**BEDFORD REGIONAL WATER AUTHORITY
SMITH MOUNTAIN LAKE WTP &
RAW WATER PUMPING STATION / INTAKE
ELECTRICAL
INTAKE STRUCTURE
SITE PLAN**

BEDFORD REGIONAL WATER AUTHORITY
SMITH MOUNTAIN LAKE WTP &
LAKES TO FOREST WATER LINE EXTENSION
ELECTRICAL
MEMBRANE/ADMIN BUILDING
PARTIAL POWER PLAN

BEDFORD REGIONAL WATER AUTHORITY SMITH MOUNTAIN LAKE WTP & LAKES TO FOREST WATER LINE EXTENSION ELECTRICAL MEMBRANE/ADMIN BUILDING UNDER SLAB CONDUIT ROUTING POWER PLAN		DESIGNED: ZKO DETAILER: RTD CHECKED: SDS APPROVED: DATE: 01/11/16	PROJECT NO. 182262 E-30-407 SHEET OF
BLACK & VEATCH Building a world of difference. Black & Veatch Corporation Virginia Beach, VA		ISSUED FOR CONSTRUCTION REVISIONS AND RECORD OF ISSUE NO. BY CHK APP 0 ZKO SDS DATE 11/11/16 DWG: C:\DW\Working\Unw\americas\182262\182262-E-30-MEMBRANE.BV.rvt XREF1: XREF2: XREF3: XREF4: PLOTTED: 1/12/2016 10:49:29 AM USER:	SCOTT D. STOKKAN Lic. No. 0402-032019 1/1/2016 PROFESSIONAL

1 ENLARGED UNDER SLAB POWER PLAN - OPERATING FLOOR
3/8" = 1'-0"

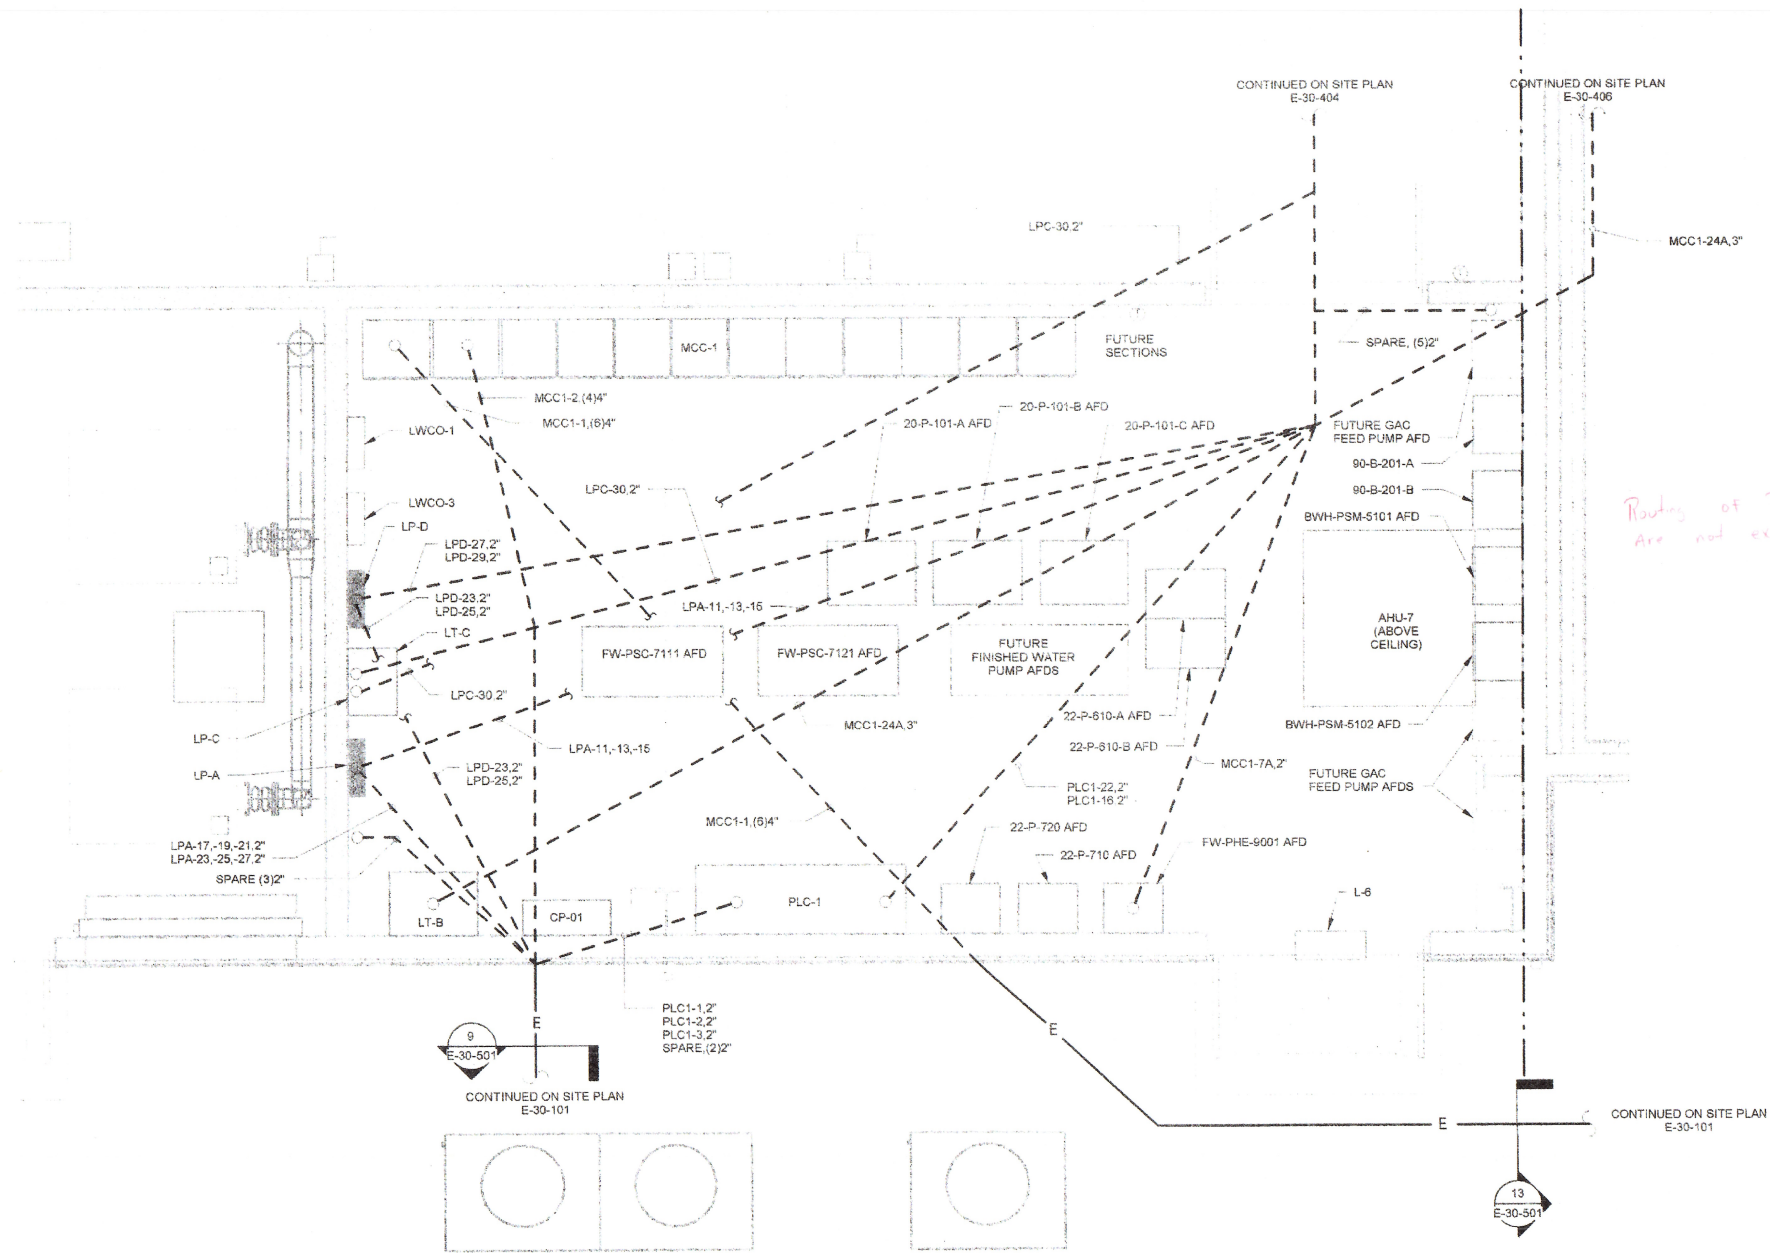
Routing of These Conduits Shown
Are not exactly as shown.

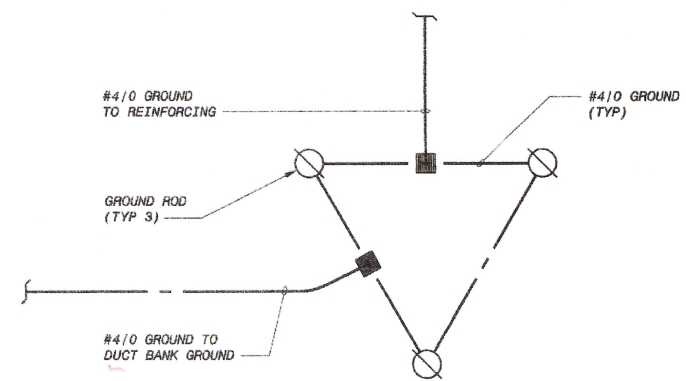
GAC
Remote I/O GAC DRIVE
RFI 38

RFI 37
